#### SUPPORTING AMENDMENT NOS. 7 & 4 TO LICENSES NOS. DPR-29 AND DPR-30

(CHANGE NO. 16 TO APPENDIX A OF TECHNICAL SPECIFICATIONS)

QUAD-CITTES UNITS 1 AND 2

EFFECTS OF CHANGING THE PELLET-CLAD THERMAL CONDUCTANCE

FIGURE 3.5.1 MAXIMUM ALLOWABLE AVERAGE FLANAR LEGR APPLICABLE TO FUEL TYPE INITIAL CORE, TYPE I,

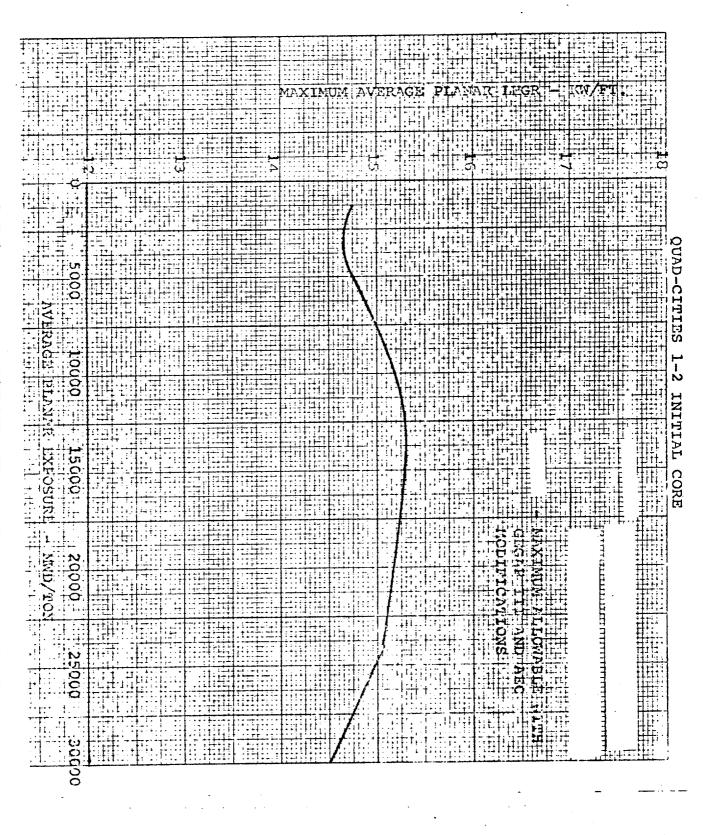
During steady state power operation, the average linear heat generation rate (LHGR) of all the rods in any fuel assembly, as a function of average planar exposure, at any axial location, shall not exceed the maximum average planar shown in Figure 3.5.1.

The maximum average planar LHGR's shown in Figure 3.5.1 are based on calculations employing the models described in the General Electric Report NEDM-10735 as modified by General Electric Report NEDO-20181, which was modified by the Regulatory staff in "Supplement 1 to the Technical Report on Densification of General Electric Reactor Fuels, December 14, 1973".
